New Model Introduction

Model GR-4400 is offered as a direct replacement for model GR-320V. Models have common mounting and tooling and are dimensionally the same except as shown.

Model GR-4400

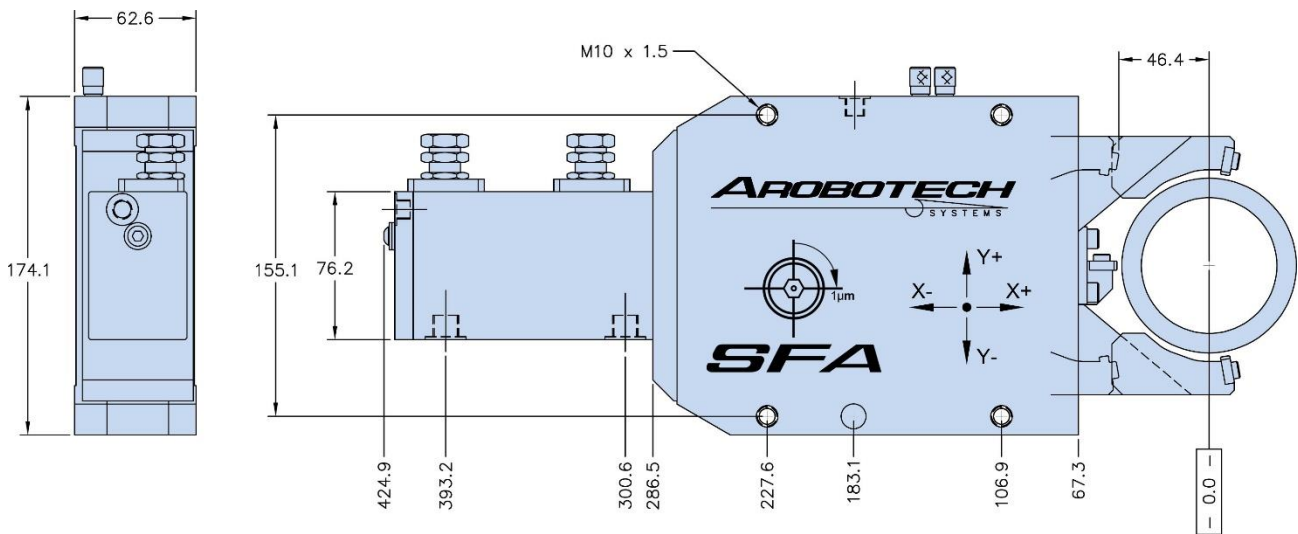
- * 10 TO 90mm Diameter
- * 11.4 cm2 Piston Area
- * 90° Turn = 0.001mm Adjustment (both axis)
- * +/- 0.200mm Total Adjustment (both axis)

- * 10 to 90mm Diameter
- * 11.4 cm2 Piston Area
- * X-Axis = 3.1° Turn = 0.001mm Adjustment ▪ ±0.22mm Total Adjustment
- * Y-Axis = 10.4° Turn = 0.001mm Adjustment ▪ ±0.07mm Total Adjustment
